**BULGA OPTIMISATION PROJECT
MODIFICATION 3 AND BULGA
UNDERGROUND MODIFICATION 7**

Response to Independent Expert Scientific
Committee on Coal Seam Gas and Large Coal
Mining Development Advice

Prepared by
Umwelt (Australia) Pty Limited
on behalf of
Bulga Coal Management Pty Ltd

Project Director: **Bret Jenkins**
Project Manager: **Kirsty Davies**
Report No. **4100/R14**
Date: **April 2020**

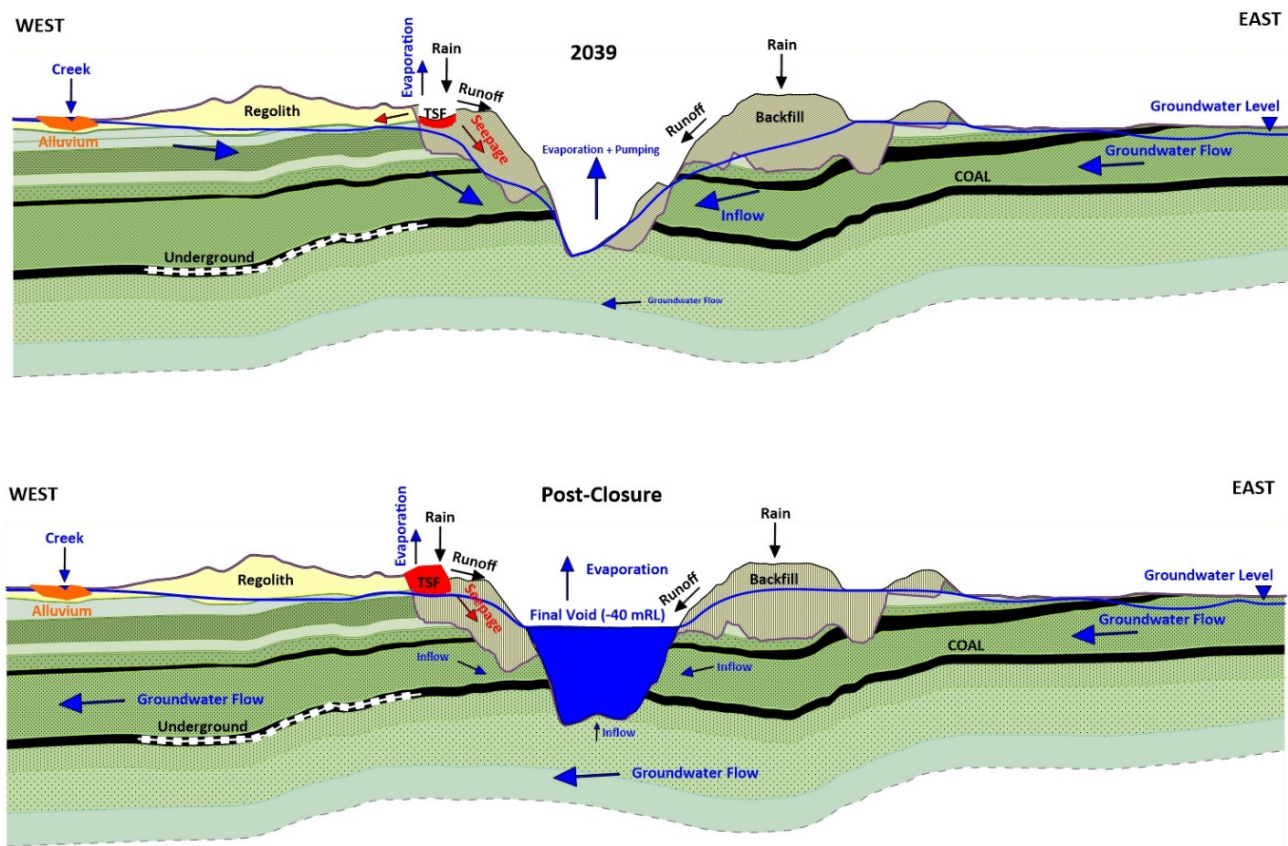
11. The proponent has not adequately modelled potential impacts of the final void in the rehabilitated landscape, including worse-case impacts on surface water. These include long-term impacts on surface water and groundwater quality (particularly salinity). More detail is needed on the range of possible rates of water level recovery (cf. KCB 2019, Figure 4-12, p. 71) to improve assessment of legacy impacts. Further information on the salt balance of the site and salt sources and stores within the final landform should be provided by the proponent (discussed further in Paragraphs 16 and 25).

Recovery of the final void water body was an iterative process between the groundwater modelling team and the surface water team. Rates of groundwater inflow/outflow at various elevations were assessed in the post-closure scenario and based on the consideration of surface water inflows, groundwater flows and evaporation, the final pit lake elevation has been assessed to be in the range of – 40 m RL. A schematic indication of the groundwater flow and other influences at closure and once the pit lake has recovered is provided by Figure 29.

- The likely final void recovered water level is at $\sim -40\text{mRL}$. At this elevation, the groundwater gradients remain strongly toward the final void (see also Figure 4-13 in KCB 2019 and the particle tracking provided by Figure 5-6).

Figure 11 Predicted Annual (Water Year) HRSTS Licensed Discharge with Approved Underground Operations

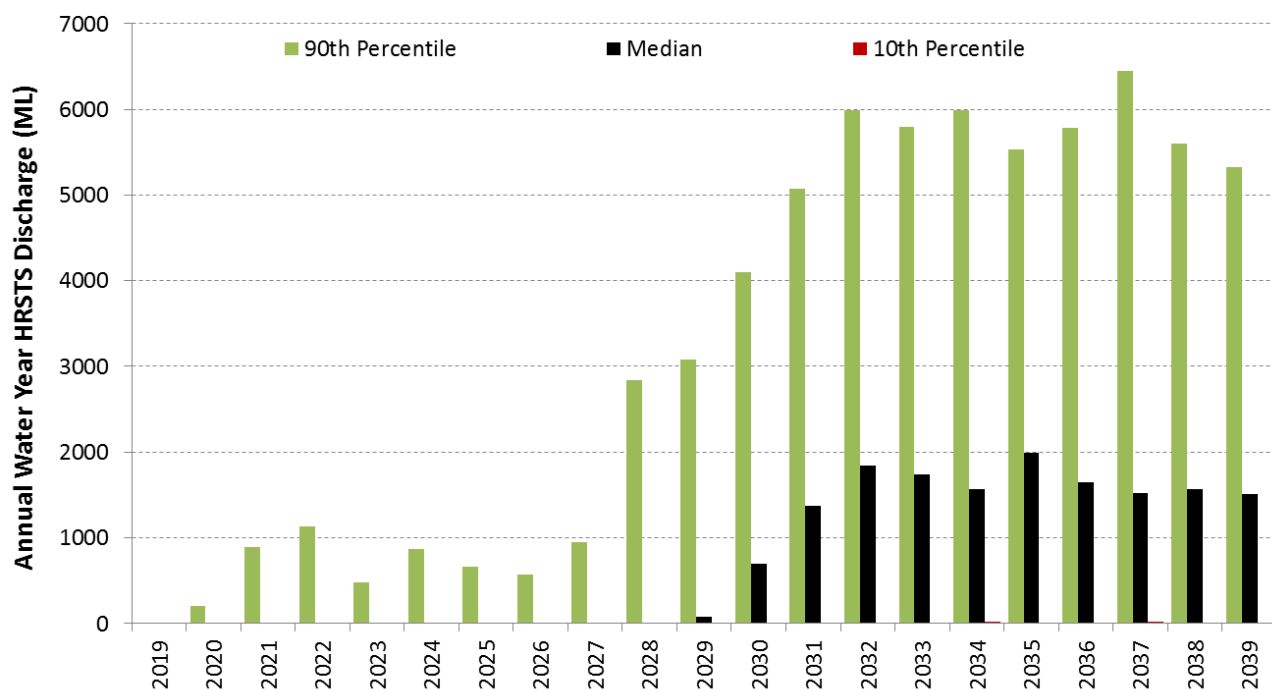
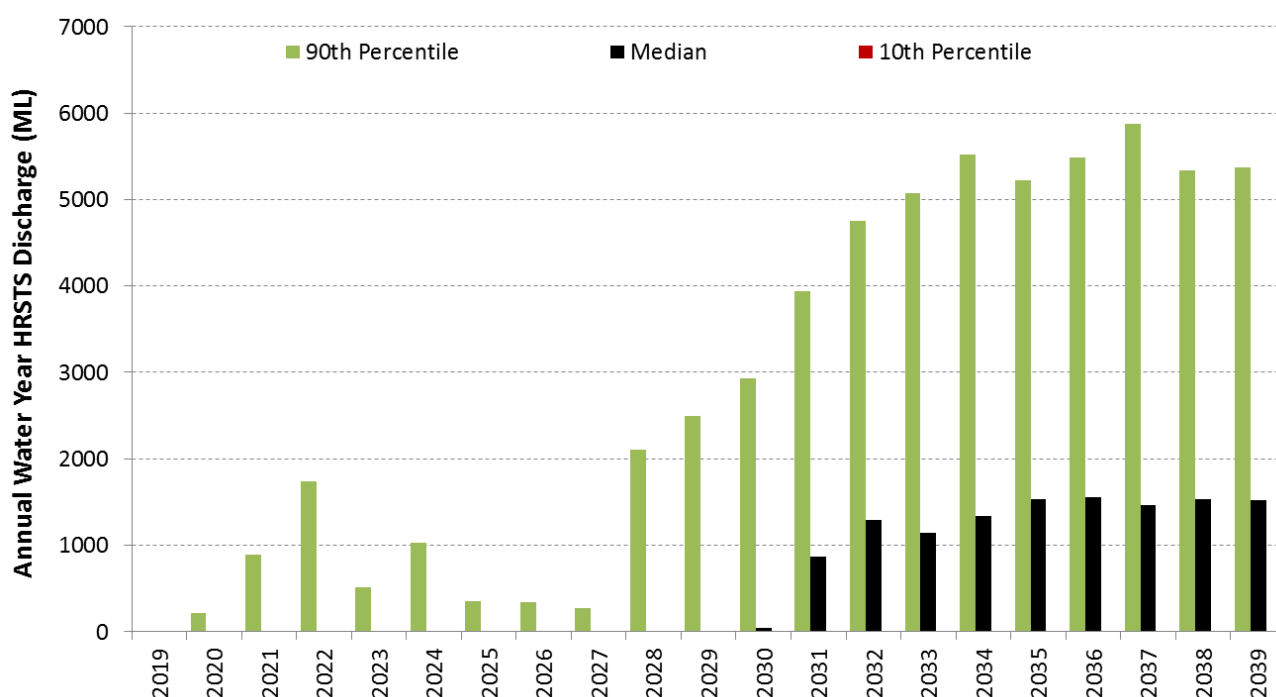
The flood modelling also did not consider potential impacts on the downstream environment from spills from the Northern and Surge Dams during high rainfall events (HEC 2019, Figures 31-33, p. 39). The IESC recommends a sensitivity analysis should be undertaken to assess the likely impacts of a range of rainfall events (including extreme events), and the potential for spillage post-mining by considering climate change. The influence of climate change on expected storage levels in these dams could be informed through the use of the Climate Futures Framework and Tools (Whetton et al. 2012) (<https://www.climatechangeinaustralia.gov.au/en/climate-projections/climate-futures-tool/projections/>) which allows for various climate regimes to be simulated.

Model predicted annual (water year) licensed releases in accordance with the HRSTS are summarised in Figure 11 to Figure 13 at different probabilities. Annual patterns are again similar to those shown in Figure 31 to Figure 33 of HEC (2019), with either little change or a slight decrease in volumes due to reduced site runoff as a result of the application of the climate change factors given in Table 1.

Patterns of annual release are similar to those shown in Figure 31 to Figure 33 of HEC (2019) with generally slightly decreased annual volumes (refer also Figure 1).

The volumes of water proposed to be released in accordance with the HRSTS and the provisions of Environment Protection Licence (EPL) 563 are summarised in Figure 31 to Figure 33 of HEC (2019) and above in Figure 11 to Figure 13. Timing of releases would be in accordance with high or flood flow events in the Hunter River as prescribed by the HRSTS as well as the need to discharge from the site water management system (refer Section 3.2.12 of HEC [2019]). Storage of water within underground goafs is in line with the existing Project Approval and water is transferred into and recovered from the Beltana goaf. No releases are proposed from the underground goaf water storages. Releases would predominantly occur from the Northern Dam. Forecast salinity in the Northern Dam for the mine case of no further underground operations is shown in Figure 17.

Figure 14 Final Void Modelled Groundwater Flux Rates

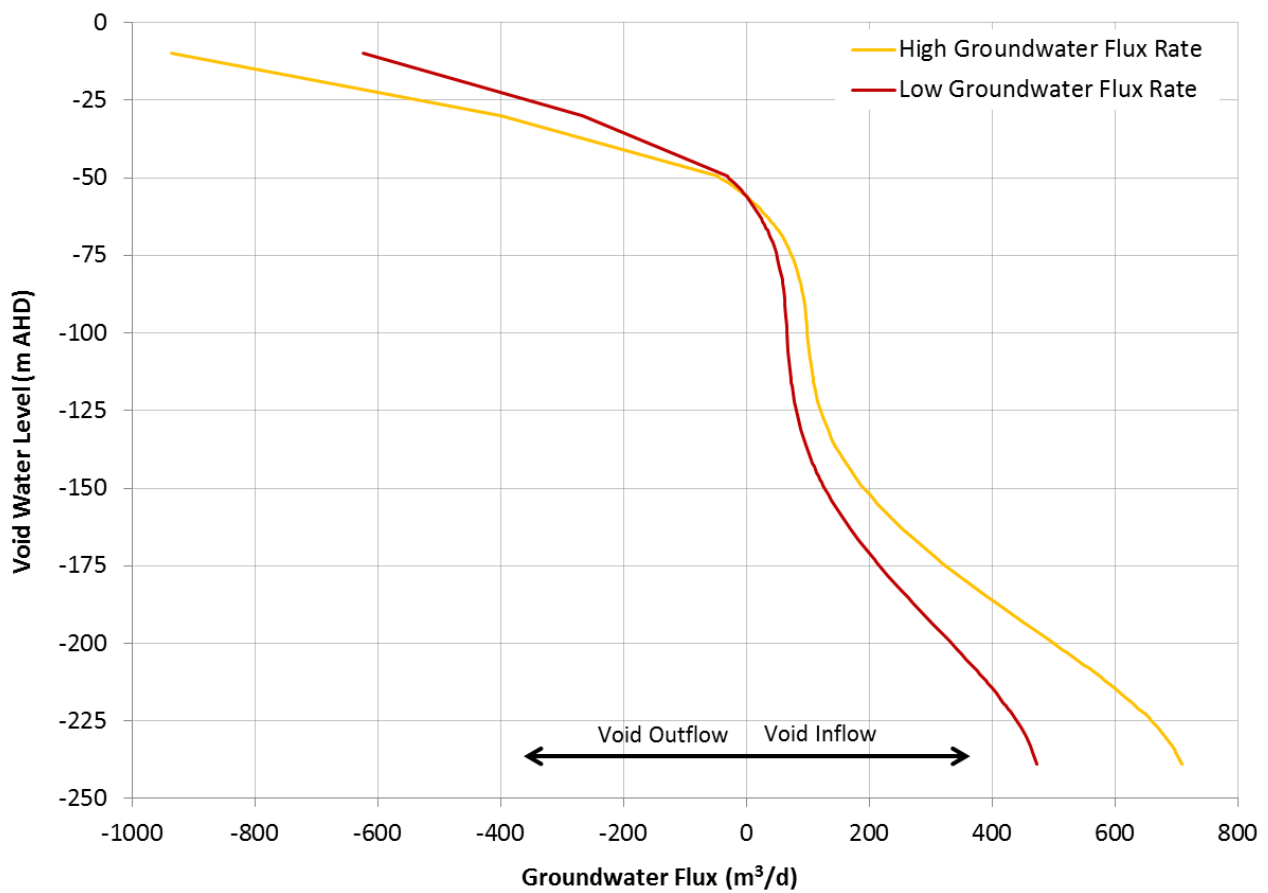
“The proponent has not adequately modelled potential impacts of the final void in the rehabilitated landscape, including worse-case impacts on surface water. These include long-term impacts on surface water and groundwater quality (particularly salinity). More detail is needed on the range of possible rates of water level recovery (cf. KCB 2019, Figure 4-12, p. 71) to improve assessment of legacy impacts. Further information on the salt balance of the site and salt sources and stores within the final landform should be provided by the proponent (discussed further in Paragraphs 16 and 25).”

In terms of “worse-case impacts on surface water”, other than the final void (lake) itself there should be no impacts on surface water because the void is not predicted to spill. Per Figure 38 of HEC (2019), final void water balance modelling indicates that the final void water body would reach an equilibrium level well below spill level. Note that Figure 38 of HEC (2019) shows a difference between the equilibrium final void water level and the spill level of approximately 94 m whereas the text below Figure 38 indicates that the equilibrium water level is approximately 120 m below spill level. The reason for this inconsistency is that the plotted spill level on Figure 38 represents the planned lowest spill point through emplaced spoils, whereas the 120 m was calculated based on the depth below the lowest point on the perimeter of the final landform. In the analysis described below the spill level for the final void has been adopted as the planned lowest spill point through emplaced spoils.

In order to further investigate the sensitivity of final void water balance model results to the rates of water level recovery additional final void water balance simulations were undertaken with increased and decreased rates of groundwater flux (inflow and outflow). Updated forecast groundwater flux rates were obtained from KCB⁵ and used to develop two groundwater flux versus void water level relationships (in consultation with Umwelt [Australia] Pty Limited). The adopted flux relationships are shown in Figure 14.
